HWY. No. 2LOCATION Failure of Embankment4 km W of WardsvilleNo of PAGES - 1

**Re: Inspection of Highway 2 Embankment  
4 km West of Wardsville  
Highway 2, District 32, Chatham**

Re: Restoration of Embankment  
Hwy. 2, 4 km West of Wardsville  
Contract No. 32-95-02 (WP 300-92-00)  
District 32, Chatham

Re: Restoration of Embankment (Stn. 14 + 567 to Stn. 14 + 625)  
W.P. 300-92-00, Highway 2, District 32, Chatham

Fig 3 - RECOMMENDED SLOPE FOR RESTORATION

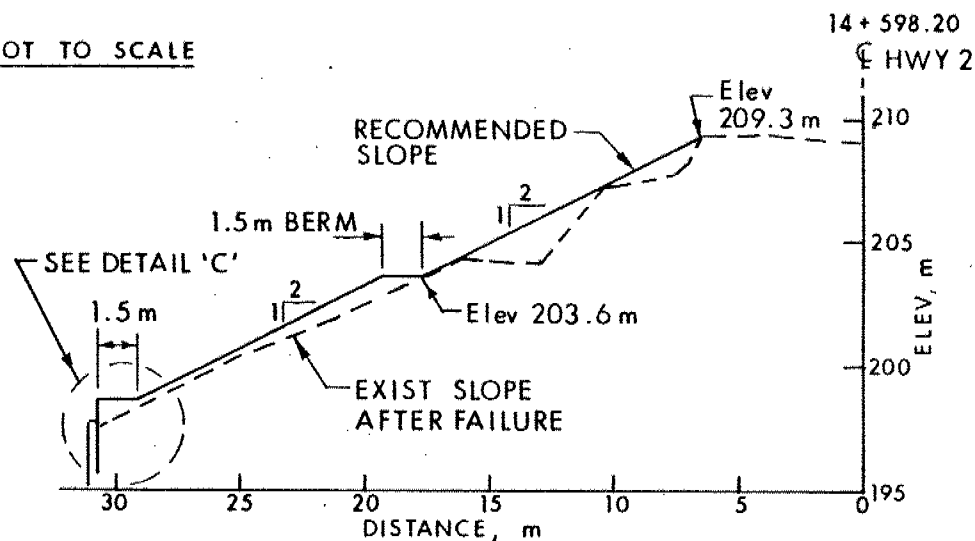
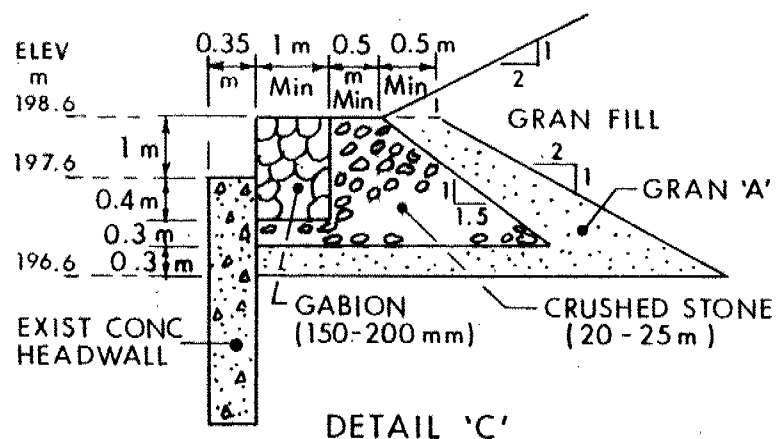
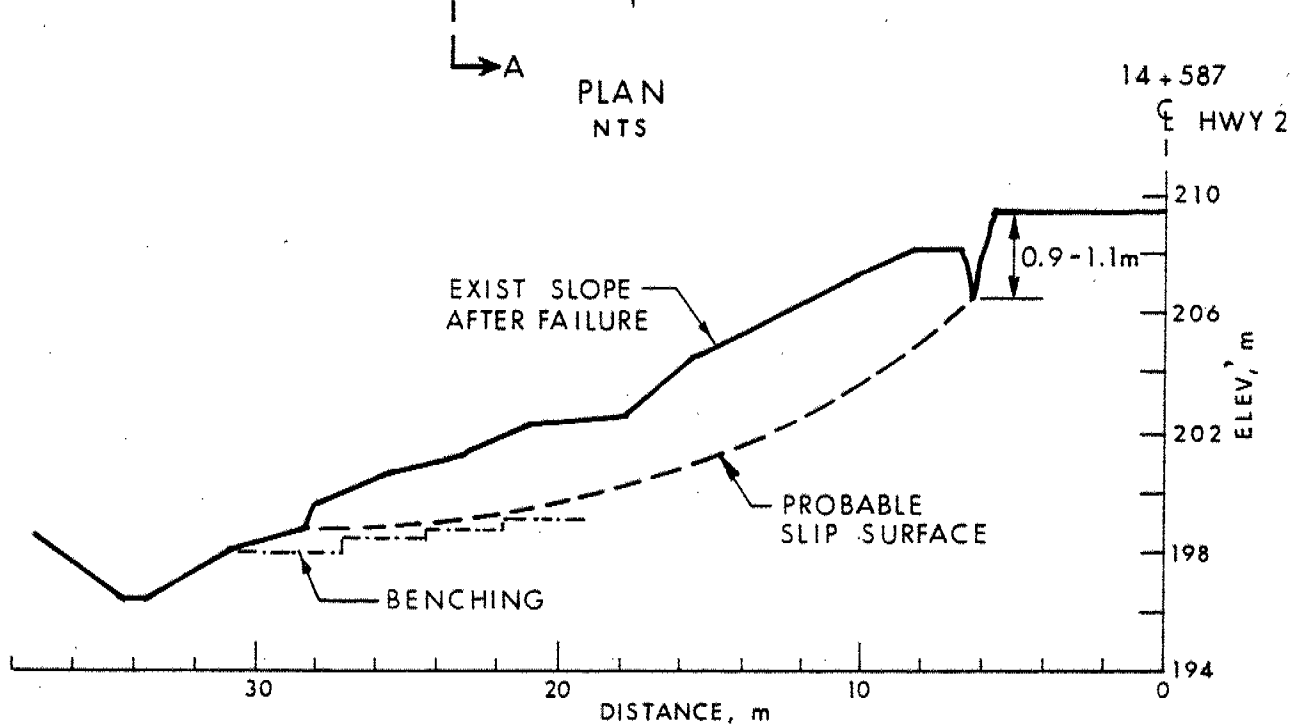
The recommended gabion adjoining the head wall should be placed at least 0.3 m to 0.4 m below ground level and extend to a height of 1.0 m (El. 198.6) above the head wall to accommodate 1.5 m wide berm around El. 203.6 (refer to Figure 2 & 3). However, near the crown of the culvert, depth of 0.3 m to 0.4 m into the ground may not be feasible and this may be reduced according to the availability of space.

- 1) Subexcavate in 3 m strips toward the slope as shown on figure 4 to avoid any failure of adjoining area.
- 2) Place the gabion, crushed stone (20 mm to 25 mm) and Granular "A" as per Figure 3.
- 3) On completion of placing crushed stone and Granular "A" and compacting, subexcavate the rest of the strip below the slip surface with the provision for benching and backfill (for sequence of construction refer to figure 4).
- 4) Backfilling of the subexcavated portion should be carried out prior to the commencement of the excavation of a new strip.
